Monticello Nuclear Generating Plant
Docket 50-263
License No. DPR-22

Response to Request for Additional Seismic Information for a License Amendment
Request for Contingent Installation of a Temporary Fuel Storage Rack in the Spent Fuel
Pool (TAC No. MD0302)

SEISMIC RAI RESPONSE

**EVALUATION OF THE 8X8 SPENT FUEL STORAGE RACK
TO DETERMINE THE NATURAL FREQUENCIES**

Time History Response Spectrum Comparison

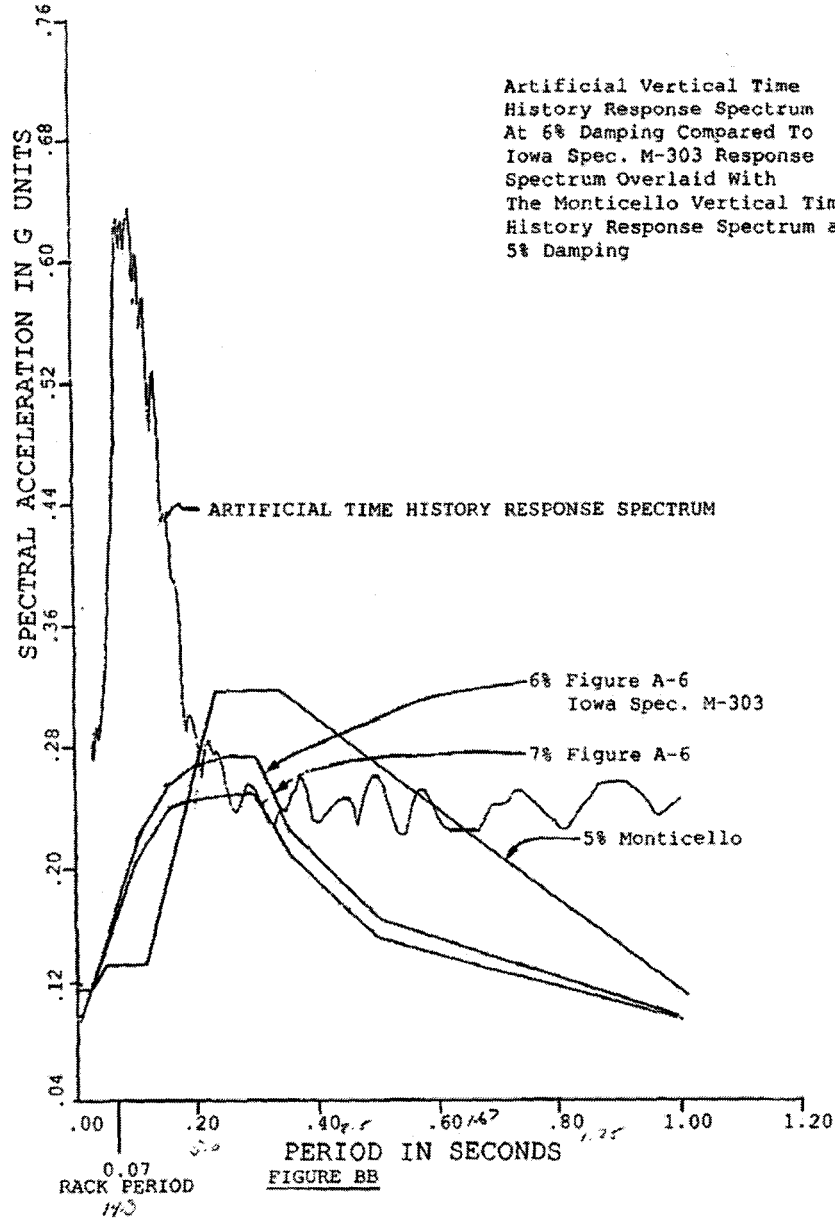
- (1) The frequency ranges at which the maximum spectral acceleration amplitude appears differ significantly between Iowa, Monticello response spectra and that from an artificial time history, as tabulated below (based on Figure AA and BB of Enclosure 1 of the 9/7/06 submittal):**

The Figure AA and BB and the above table indicate that the two response spectra (Iowa and Monticello sites) are significantly different, especially for the horizontal component of the ground motion. More important, contrary to the assertion made by NMC (Section 3.0 (3) of Enclosure 1 to the 9/7/06 letter), the time history spectrum used in the seismic response analysis does

not envelop the specific spectrum (Monticello plant site) as required by RG 1.60.

While it is true that both the vertical and horizontal artificial time history response spectrums shown on Figures AA and BB do not envelope the MNGP floor response spectrum over the entire frequency range, the fundamental frequencies used in the PaR analysis are 14.0 Hz vertical and 8.0 Hz horizontal. In the range of fundamental frequencies for the PaR 8x8 fuel storage rack (23 Hz vertical, 9 Hz horizontal, Enclosure 2) to zero period (∞ Hz) the artificial time history response spectrum does bound the MNGP response spectrum by a wide margin. Thus the seismic loading used in the 1977 PaR Systems Report will bound loads from a seismic evaluation using the MNGP response spectrum.

It should be noted that the MNGP does not have a 6 percent damping response spectra. The 5 percent MNGP response spectra is plotted on Figures AA and BB to compare to the artificial time history response spectrum which was for a 6 percent damping. A 6 percent damping response spectra for the MNGP would be lower than the 5 percent shown.

is presented in Attachment A. The comparison shows that the Iowa Spec. M-303 envelopes the MNGP response spectrum both vertically and horizontally in frequency ranges that are higher than 5 Hz and 2.5 Hz, respectively. Since the 8x8 fuel rack natural frequency lies within this range, it can be concluded that the Iowa Spec. M-303 loads shall always be larger than MNGP. Thus, the original qualification report [1] should insure the 8x8 fuel rack configuration as well.
